Access Compliance Report

Public Rights-of-Way

Intersection ID: 7726	Main Street: HIDDEN_VALLEY_RD	Cross Street: MEBANE_DR	Location:	NW
ADA ID: B76A708C9AF4	Ramp Type: Perp	Initial Pass/Fail: Fail	Overall Compliance: No	Severity Score: 10

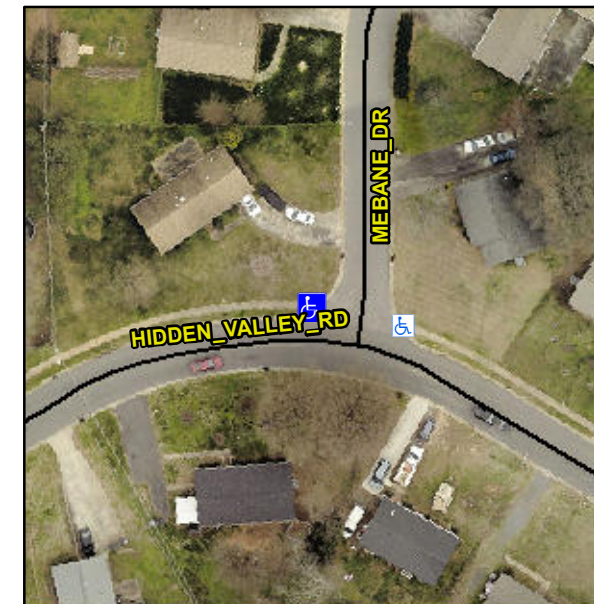
Not Found, R304.5.1, R304.5.3

Compliance	Description	Data	Compliance	Description	Data
N/A	Ramp Length (in)	61.5	Yes	Ramp Slope (%)	7.4
No	Ramp Width (in)	47.5	No	Ramp XSlope (%)	3.3
N/A	Flare Type LT	N/A	N/A	Flare Type RT	N/A
N/A	Flare Slope LT (%)	N/A	N/A	Flare Slope RT (%)	N/A
N/A	Flare Traversable LT?	N/A	N/A	Flare Traversable RT?	N/A
N/A	Landing Length (in)	N/A	N/A	DWS Provided?	N/A
N/A	Landing Width (in)	N/A	N/A	DWS Contrast?	N/A
N/A	Landing Slope (%)	N/A	N/A	DWS Length (in)	N/A
N/A	Landing X Slope (%)	N/A	N/A	DWS Full Width?	N/A
N/A	Landing Curb? (Y/N)	N/A	N/A	DWS Offset (in)	N/A
N/A	Shared Landing?	N/A			
N/A	Gutter Ponding?	N/A	N/A	Gutter Slope (%)	N/A
N/A	Gutter Lip Ht (in)	N/A	N/A	Gutter X Slope (%)	N/A
N/A	Painted X Walk1?	No	N/A	Painted X Walk2?	N/A
	X Walk 1 Direction	To E		X Walk 2 Direction	N/A
N/A	X Walk 1 Width (in)	N/A	N/A	X Walk 2 Width (in)	N/A
	X Walk 1 Slope (%)	2.4		X Walk 2 Slope (%)	N/A
	X Walk 1 X Slope (%)	0.4		X Walk 2 X Slope (%)	N/A

Remove & Replace Entire Ramp.
